FORM 5
ENVIRONMENTAL IMPACT ASSESSMENT ORDINANCE
(CHAPTER 499)
SECTION 13(1)

Application for Variation of an Environmental Permit

C2. Application No. of the Current Environmental Permit : EP-292-2007

**TYPICAL BASE LINER
(INDICATIVE)**

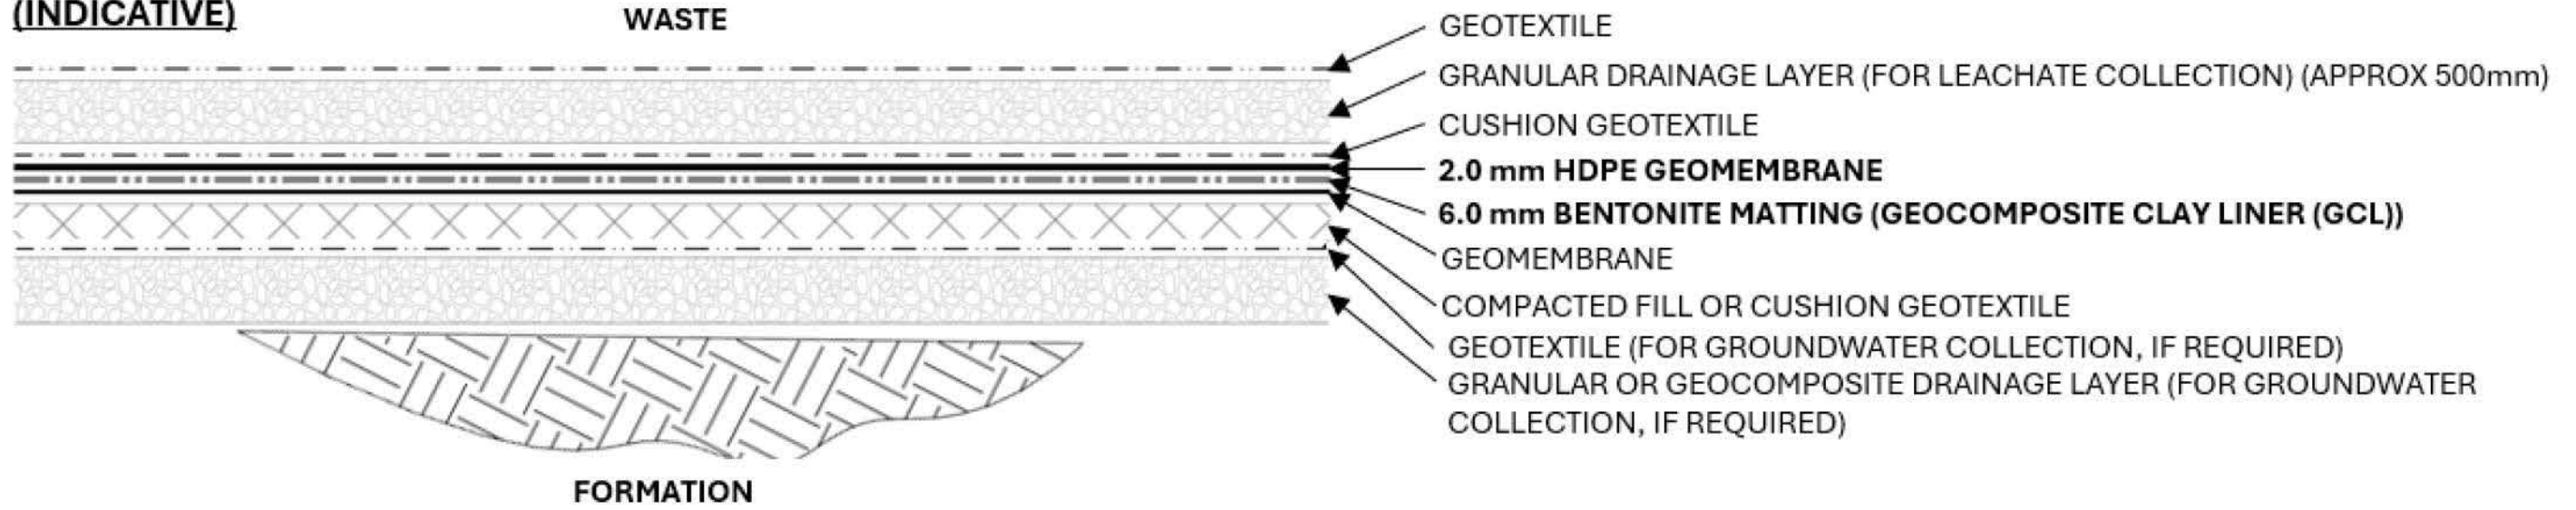
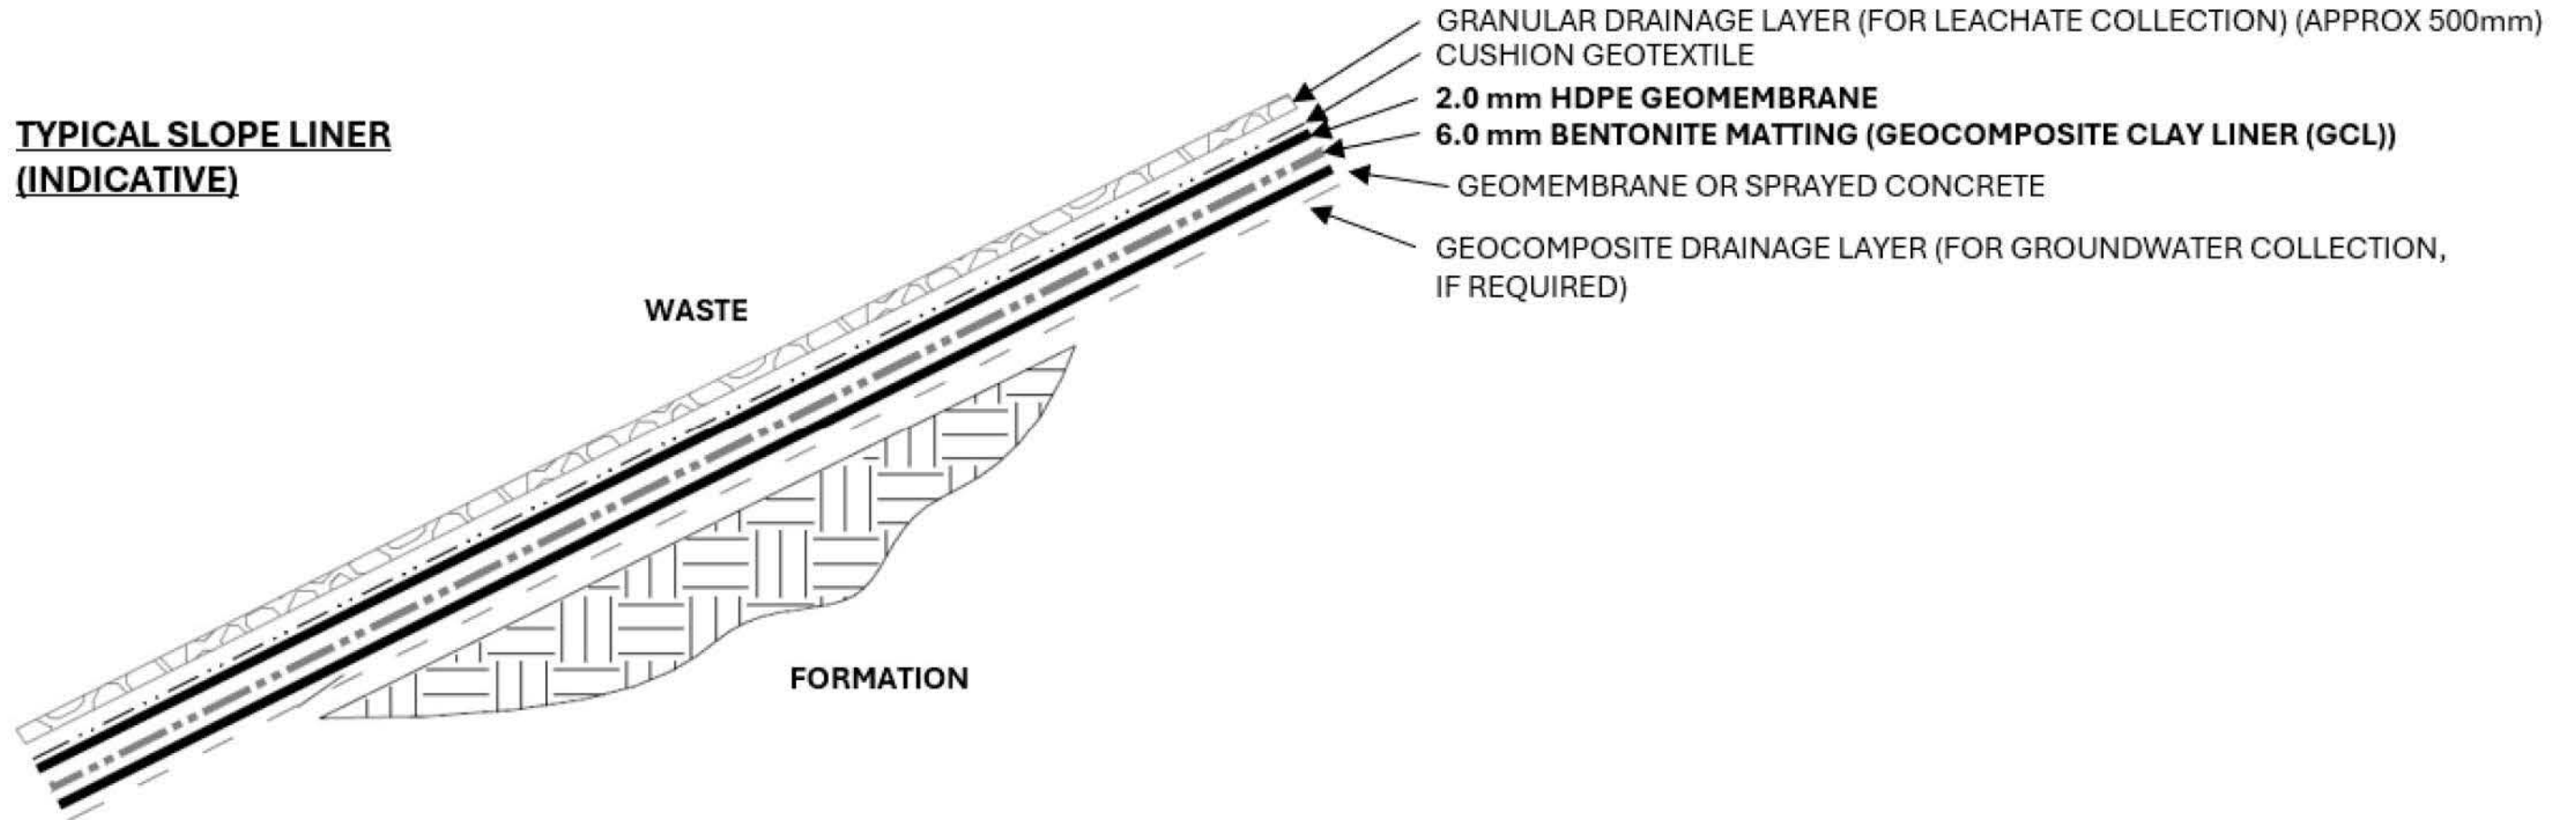
2.4.3 In this connection, in order to properly reflect the latest design of the Multi-layer Composite Liner System for the NENTX Project, it is proposed that a drawing illustrating the typical sections of Multi-layer Composite Liner system could be included into the EP Condition 2.19 (for EP-292/2007) and FEP Condition 2.17 (for FEP-02-292/2007). With an aim to reflecting the latest liner system design of the NENTX Project, the environmental performance requirement set out in the approved EIA Report will not be violated. Prior agreement from EPD should be sought in the event of any variation in the design principle of the Multi-layer Composite Liner system.

- 2.4.2 In fact, following the design principles of contemporary landfill liner system, the Multi-layer Composite Liner System, which comprises of the following key components, and each component performs an important function for achieving the engineering performance of the liner system and protection of the surrounding environment, are proposed for the NENTX Project (refer to **Figure 2.2**).
